STATE OF VERMONT
AGENCY OF TRANSPORTATION

PROPOSED IMPROVEMENT
BRIDGE PROJECT

ROUTE NO: TH 2, FAS 105, (MAJOR COLLECTOR) BRIDGE #32

RECORD PLANS

TYPICAL BRIDGE SECTION
(40:1 SCALE)

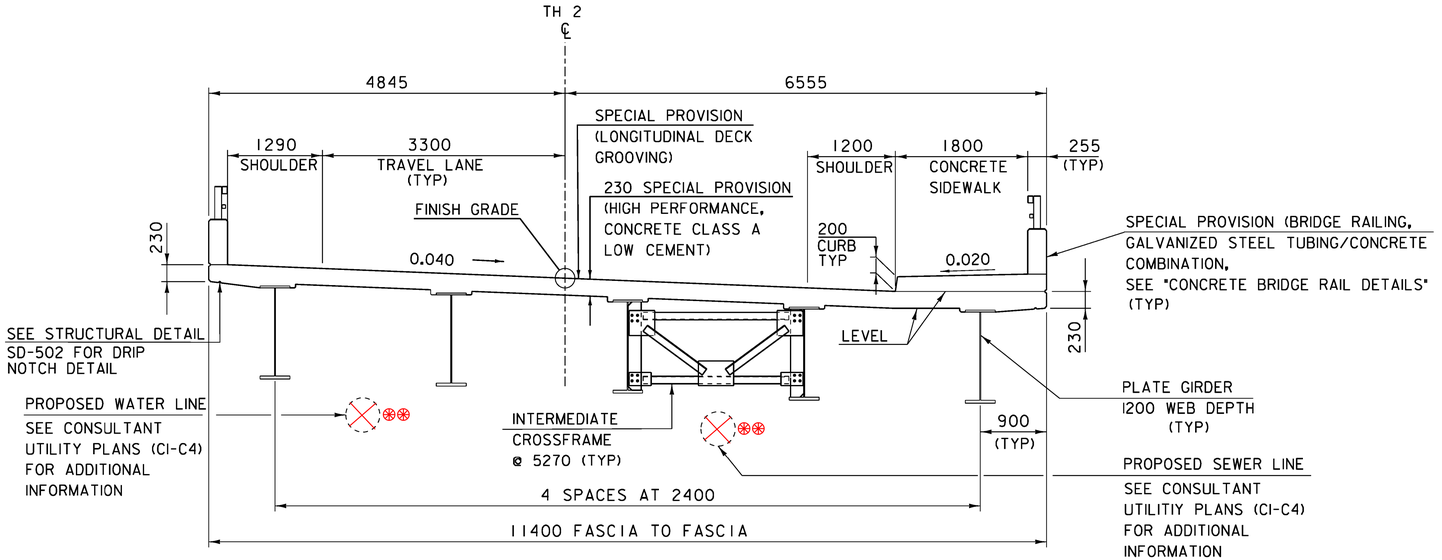
⊛⊛ TOWN DID NOT WANT THESE (TOO LOW) AND CHANGES WERE MADE. SEE CHANGE ORDER #4, DATED 10/17/13

FILE NAME: 89J088/STR/s89J088utilbdr.dgn
PROJECT LEADER: J. LACROIX
DESIGNED BY: W. PELLETIER
DRAINAGE LAYOUT SHEET 1
PLOT DATE: 07-MAR-2012
DRAWN BY: G. ROKES
CHECKED BY: W. PELLETIER
SHEET 20 OF 90

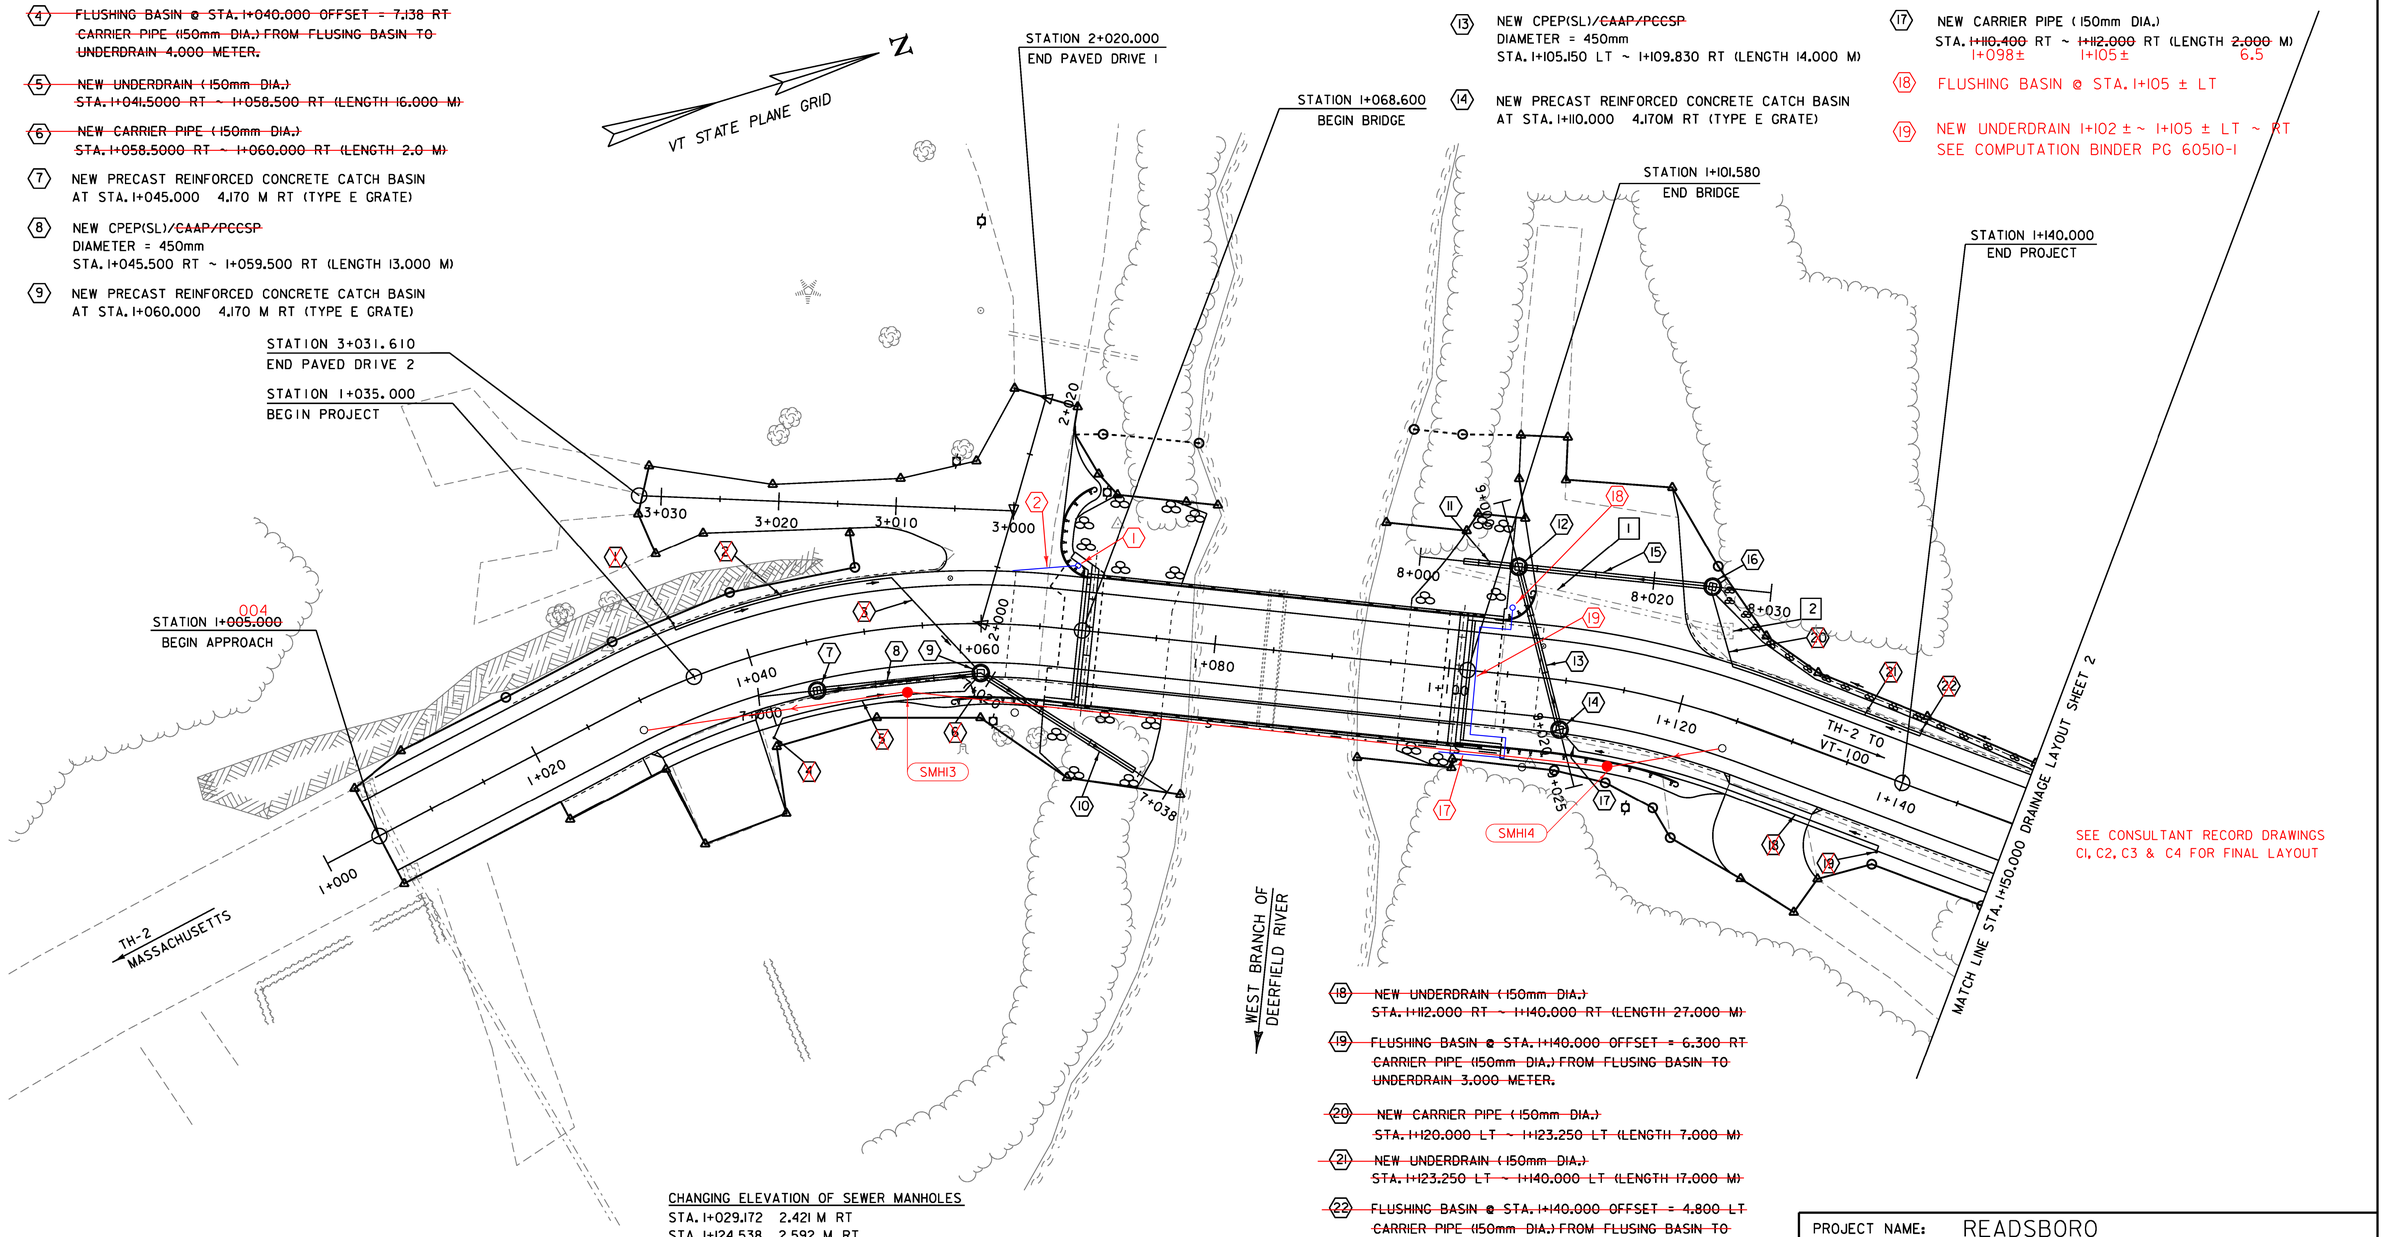
SEE CONSULTANT RECORD DRAWINGS C1, C2, C3 & C4 FOR FINAL LAYOUT

ABUTMENT #1 FOOTING REINFORCING PLAN

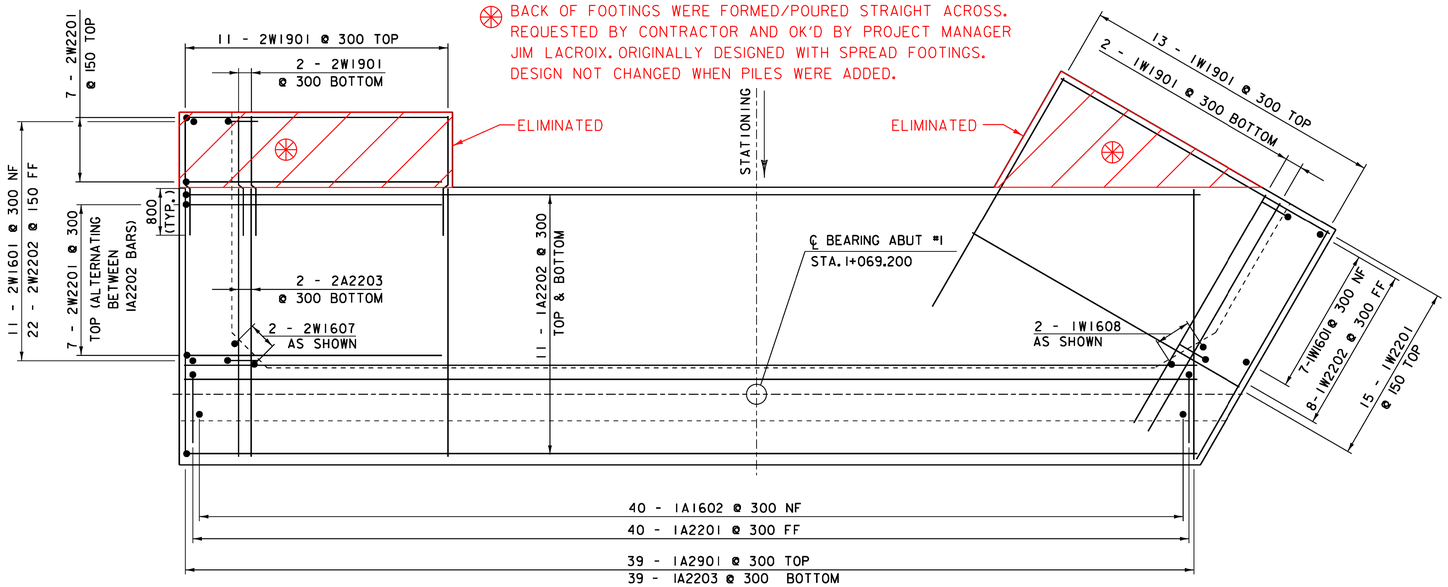
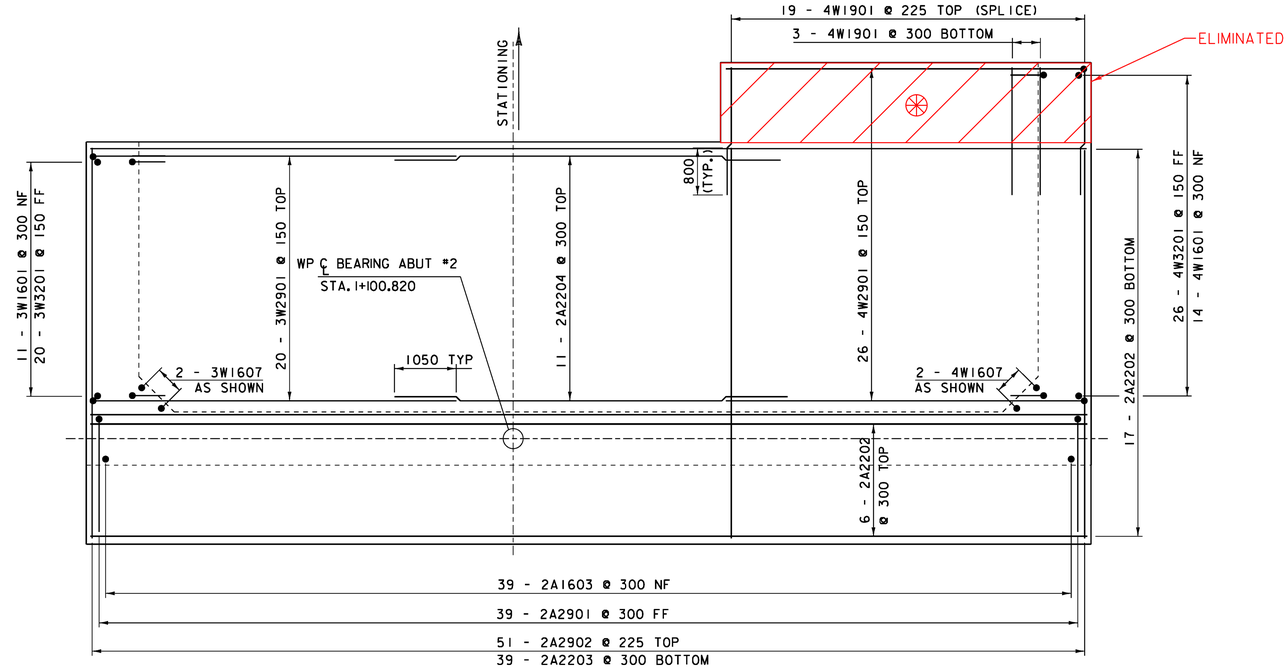
PORTION OF FOOTINGS ELIMINATED DUE TO LACK OF NEED, PILES USED! SEE SHEET 49

SEE SHEET 49 FOR PILE LOCATIONS.

ABUTMENT #1 PLAN

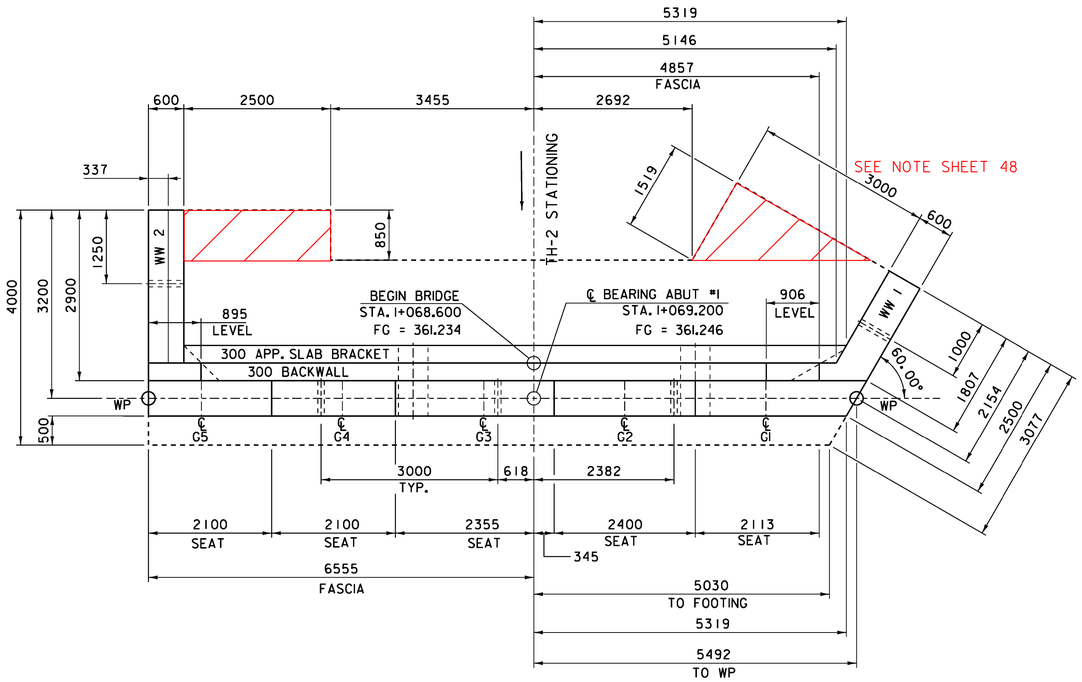
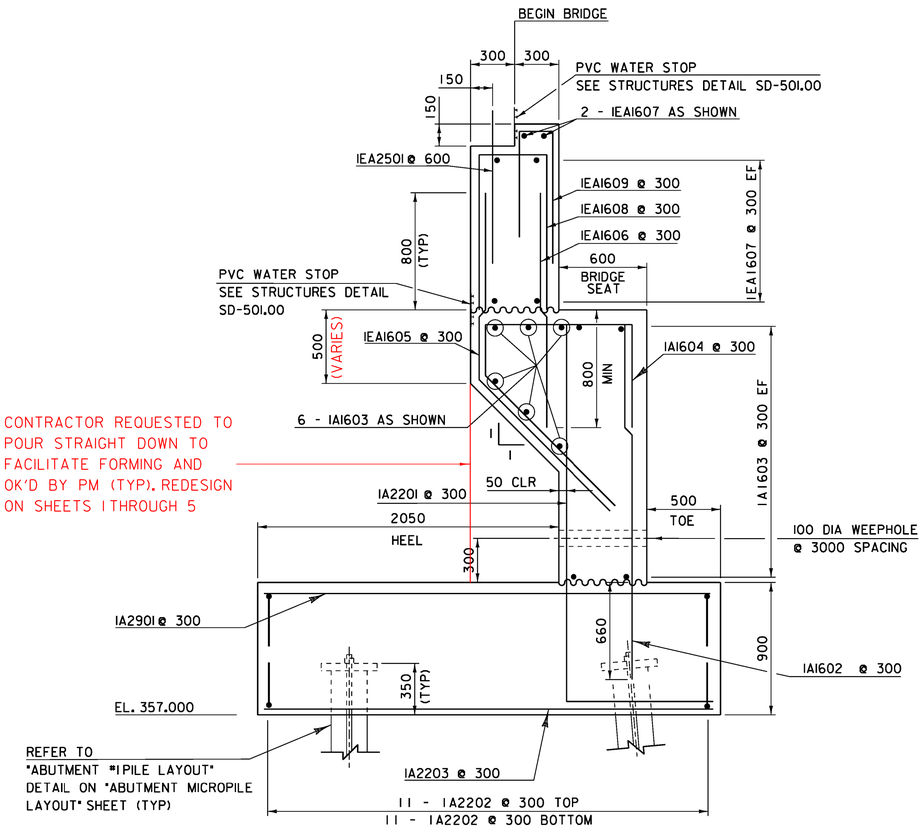
CONTRACTOR REQUESTED TO POUR STRAIGHT DOWN TO FACILITATE FORMING AND OK'D BY PM (TYP). REDESIGN ON SHEETS 1 THROUGH 5

SEE REVISED PAGES # 1~5

ABUTMENT #2 TYPICAL SECTION

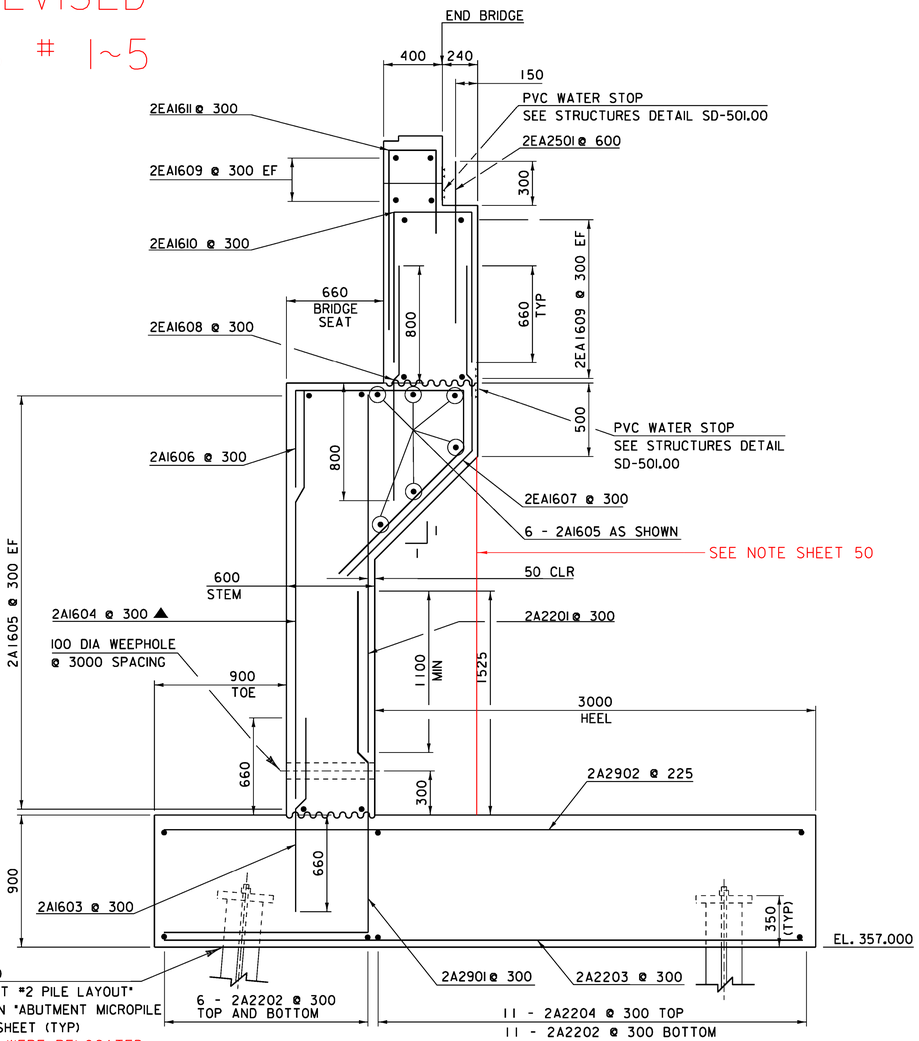
SEE REVISED PAGES # 1~5

SEE REDESIGNED ABUTMENTS SHEET 2 OF 5

APPROACH SLAB #1

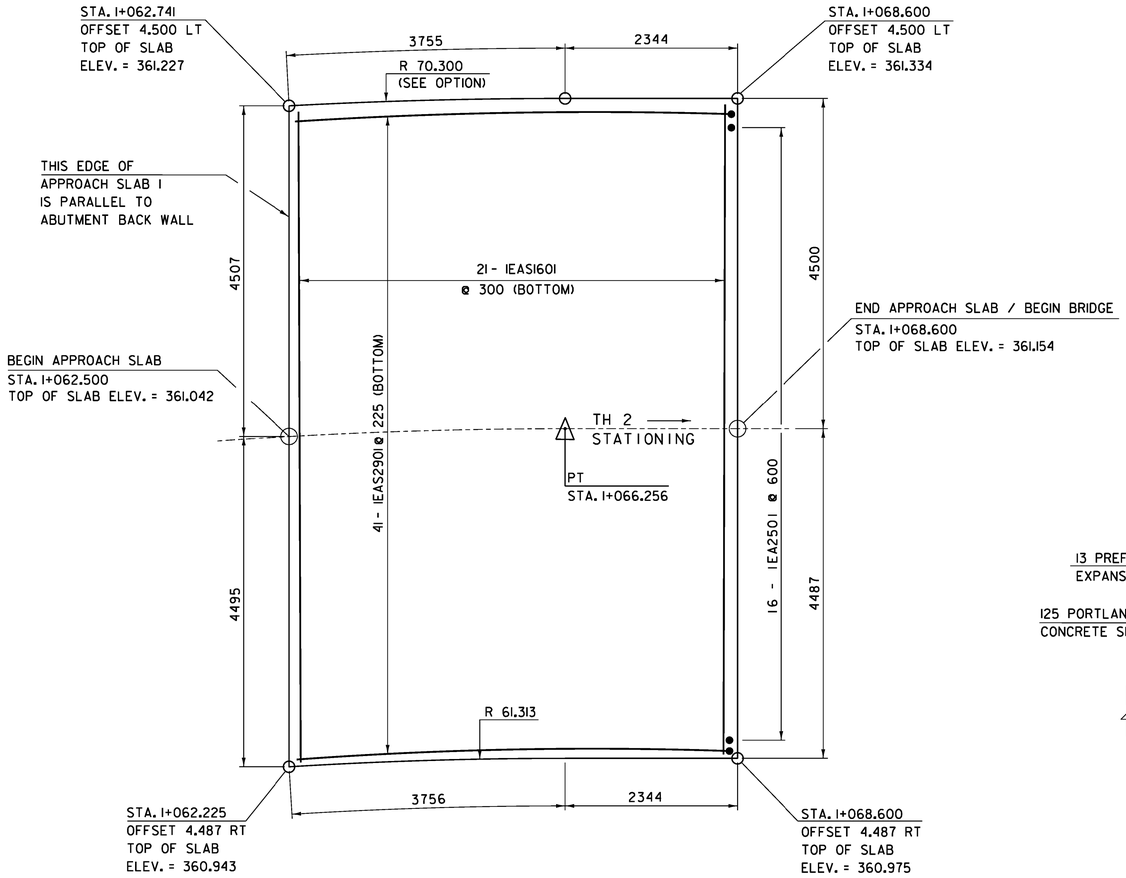
CONTRACTOR OPTION:
APPROACH SLAB RADIUS MAY BE APPROXIMATED BY STRAIGHT LINE ON THIS SIDE. NO CHANGE TO CONCRETE QUANTITIES WILL BE ALLOWED.

5+005

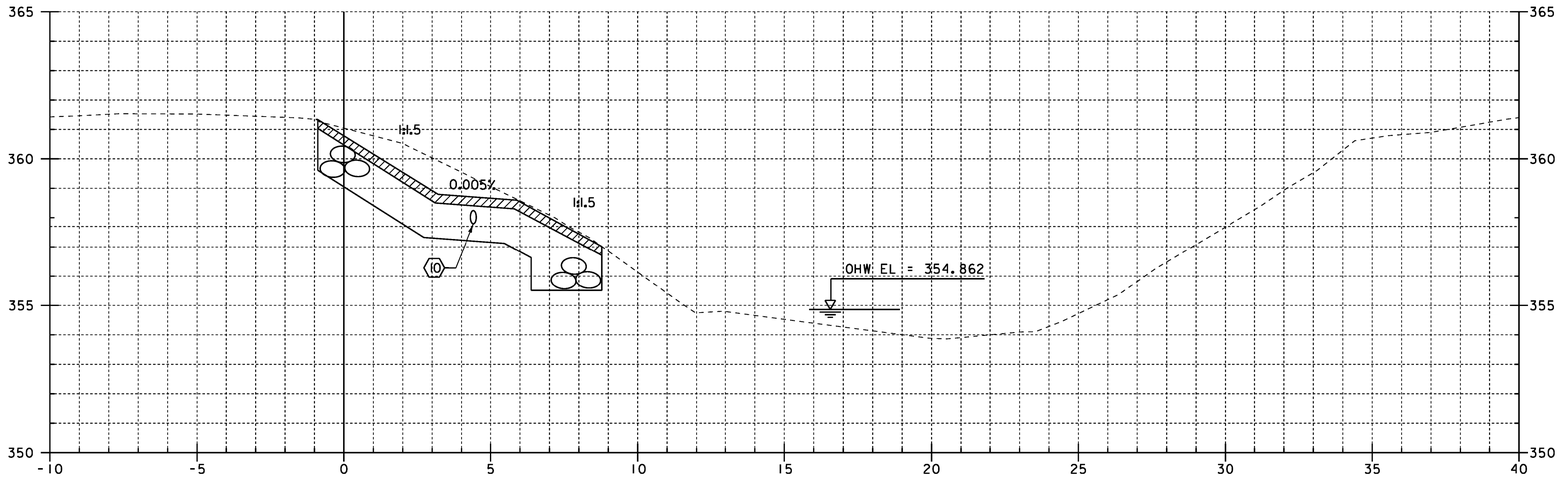
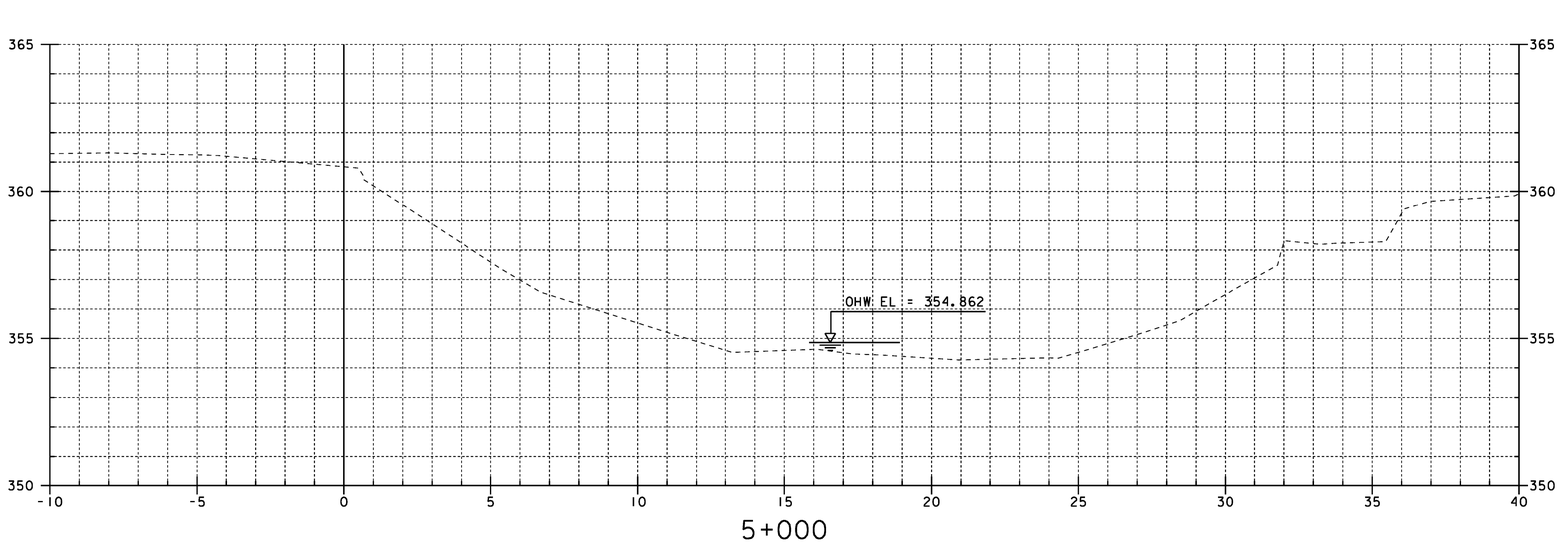
SEE NEW CHANNEL CROSS SECTIONS
